UNITED STATES PATENT AND TRADEMARK OFFICE

Office Action Summary	Application No. 10/589,091	Applicant(s) SCHIERHORN, UWE	
	Examiner JONATHAN KOAGEL	Art Unit 3744

DETAILED ACTION

Fig. 1

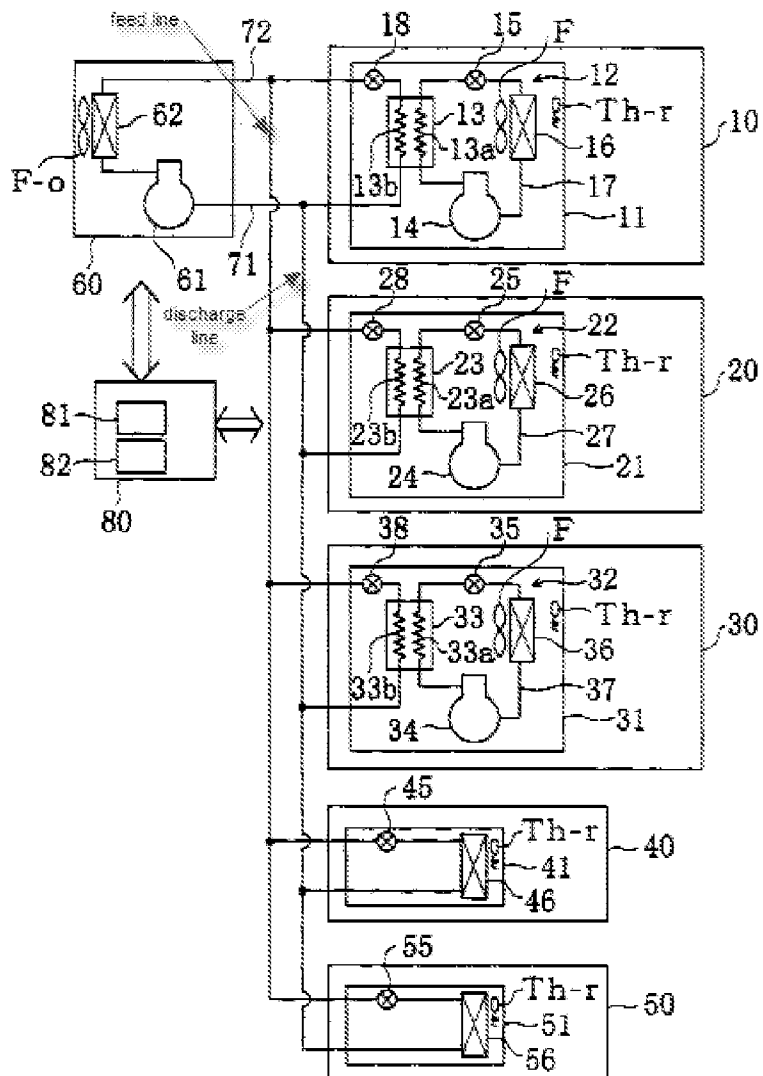
Regarding claim 1, Ueno teaches in fig. 1, a refrigeration installation having at least one refrigeration consumer 10, 20 which includes at least one evaporator 16, 26, having at least one feed line (See annotated figure below) and at least one discharge line (See annotated figure below), via which a refrigerant is fed to the at least one refrigeration consumer 10, 20 and discharged from the at least one refrigeration consumer 10, 20, the at least one refrigeration consumer 10, 20 having expansion members 15, 25 wherein, the expansion members 15, 25 comprise modified expansion valves, each said expansion member being connected upstream of the evaporator of each refrigeration consumer and each said refrigeration consumer 10, 20 being assigned a modified linear compressor 14, 24. Ueno fails to explicitly teach the

Regarding claim 15, Ueno as modified above teaches the invention as disclosed and Ueno further teaches in fig. 1, wherein the at least one refrigeration consumer 10, 20 has a dedicated closed refrigerant cycle 12, 22, the refrigerant cycle 12, 22 being operatively connected via at least one liquefier 13, 23 to the at least one feed line and the at least one discharge line, the refrigerant cycle 12, 22 in each case having modified expansion valves 15, 25 and modified linear compressors 14, 24, and the evaporator 16, 26 of said at least one refrigeration consumer 10, 20 in each case being arranged higher than the liquefier 13, 23 of the said at least one refrigeration consumer 10, 20 (column 4 lines 1-11, column 5 line 13-column 6 line 57). From a horizontal reference

point of view in fig. 1 where a left direction is defined as a lower point and a right direction is defined as a higher point, the evaporator is arranged higher than the liquefier.
